# Seattle Design Commission

## **MINUTES OF THE MEETING**

**21 July 2005**

**21 July 2005 Project: Four Seasons Hotel**

proposed Union Plaza plan

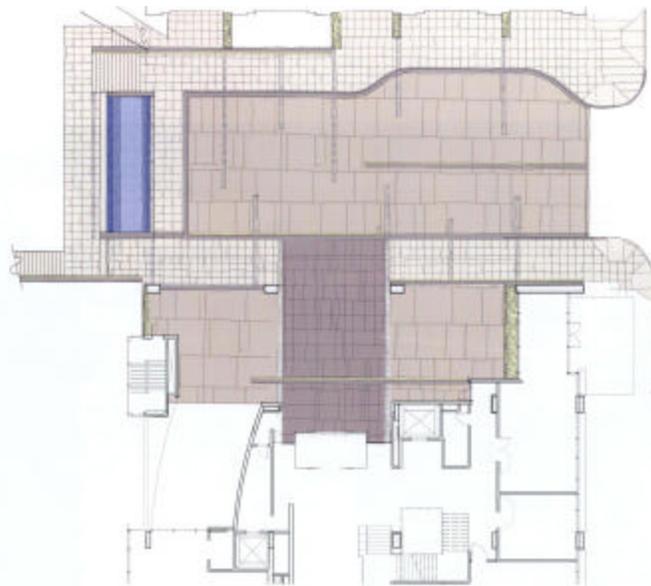
- **believes that the latest design for the Union Street upper terminus is simpler, clearer and more direct, with greater clarity regarding the public use of the void between the building and its neighbor 98 Union;**

- **asks proponents to improve pedestrian signage to clearly delineate connections to the waterfront, particularly ADA access, but to minimize the clutter in the view corridor (with vertical directional signs etc.) through creative solutions ;**

- **is of mixed sentiment regarding the clustered layout of street trees on First Avenue, and asked that proponents strengthen the street's pedestrian quality;**

- **asks that the proponents revisit their previous scheme since the Commission had appreciated the public stairs that had offered direct through-connection between upper and lower Union Street on both the north and south sides of Union;**

- **recommends that proponents work with the Seattle Department of Transportation to widen the staircase as much as structurally possible without impeding on the access and quality of the street and sidewalk below;**

- Asks what is the difference in elevation between Union Plaza level and the lower balcony.
  - Six feet
- Asks for clarification on quality of paving outside hotel lobby
  - It is the same as the floor surface from lobby, which is gray granite. Design element used to delineate auto crossing space, the sidewalks ramp down so autos can cross it

- Asks what is staircase width
  - Six feet
- Asks if there is a hotel entrance on 1<sup>st</sup> Avenue
  - No, 1<sup>st</sup> Ave it will have retail and other residential entries
- Asks if something will be required at top of first set of stairways, if they are 11 feet wide, to keep cars from driving down them
  - A bollard will most likely be used

- Conceptually the design presents itself well, and believes that the concrete structure of fountain is sufficient to stop traffic from accidentally traveling over drop, but suggests possible signage to note the dead end. Their analysis now will be down to the level of analyzing choice of material, paving, etc

- Suggests that the paving extending from lobby over sidewalk should remain as concrete to accentuate pedestrian east/west connection

- Believes that it is much improved, simpler and appreciates more generous sidewalks
- Expresses concern about the effects of the stairway of the balcony on the quality of the environment below in Post Alley

- Believes that the stairs should descend from both sides of upper plaza to lower balcony like in last presentation scheme; believes it will better support activity and finds it frustrating that this new design is an overlook but does not allow access

- Believes that six feet is too narrow for stairway, and asks that proponent widen to eight feet if possible, as previously proposed
- Believes that sidewalk material should carry all the way through south side rather than be interrupted by hotel lobby pavers

concept aerial view from the southwest

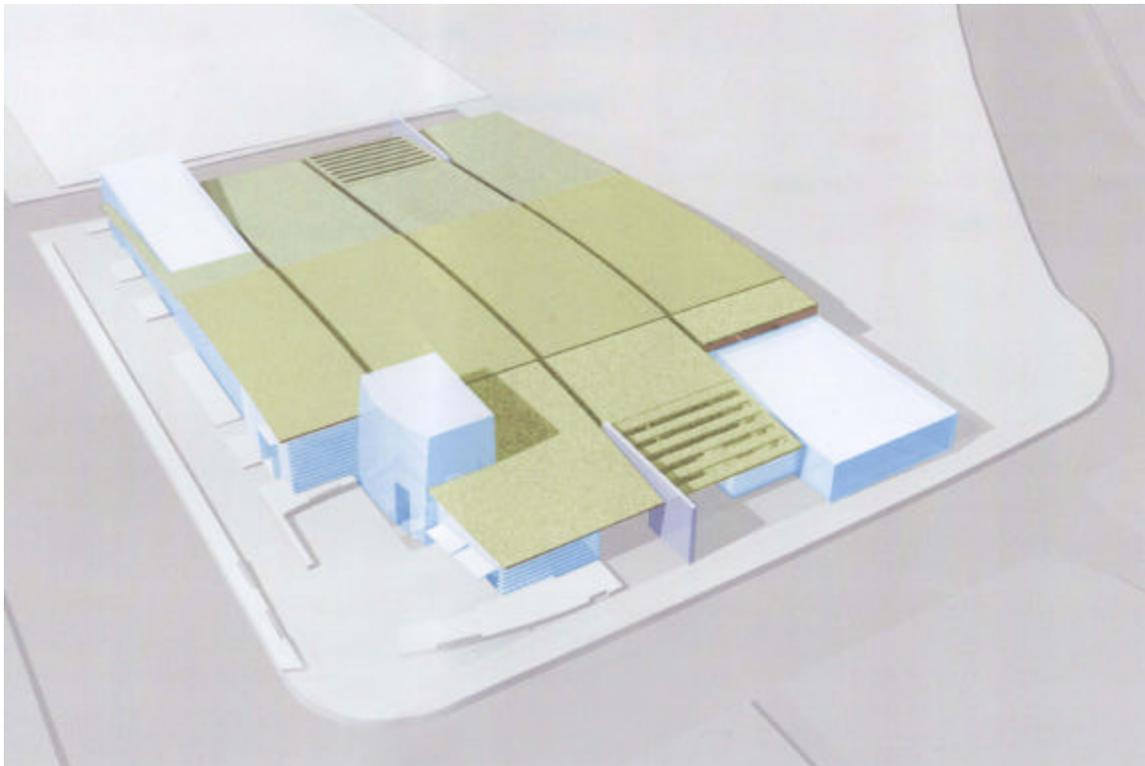
- **asks that the proponents further study the whole east façade, which has not yet been shown, and the primary vehicular entry approach along Harrison from the East. They encourage the design team to better incorporate the parking office massing and roof into the overall building design;**

- **is skeptical of the green roof components, specifically the louvered sections over the entry areas and asks proponents to further explore the function and feasibility of this design element;**

- **asks proponents to better integrate the large readerboard sign planned for Fifth and Harrison into the entry plaza design and the overall character of the project;**

- Encourages proponents to explore geometry at entry plaza and possibly simplify
- Likes the light well as an icon for building, how will it develop and how visible will it be from street if obscured by stuff in front of it, careful

- Entrances into garage, slivers of planting on roof, use finishing material from light well in the louvers instead, because little strips of planting will have trouble surviving

- Agrees, question the viability of green roof strips
- Suggests that proponents look at Sam Mockbee, Rural Studio, and Community Center for examples of glass art

- Believes that 5<sup>th</sup> and Harrison entry is much improved
- Encourages proponents to strengthen visual cues to garage from south east corner for traffic traveling from the east

- Suggests that design team further explore parking office design, it is still just box, efforts needed to make it more significant
- Suggests that east façade needs attention
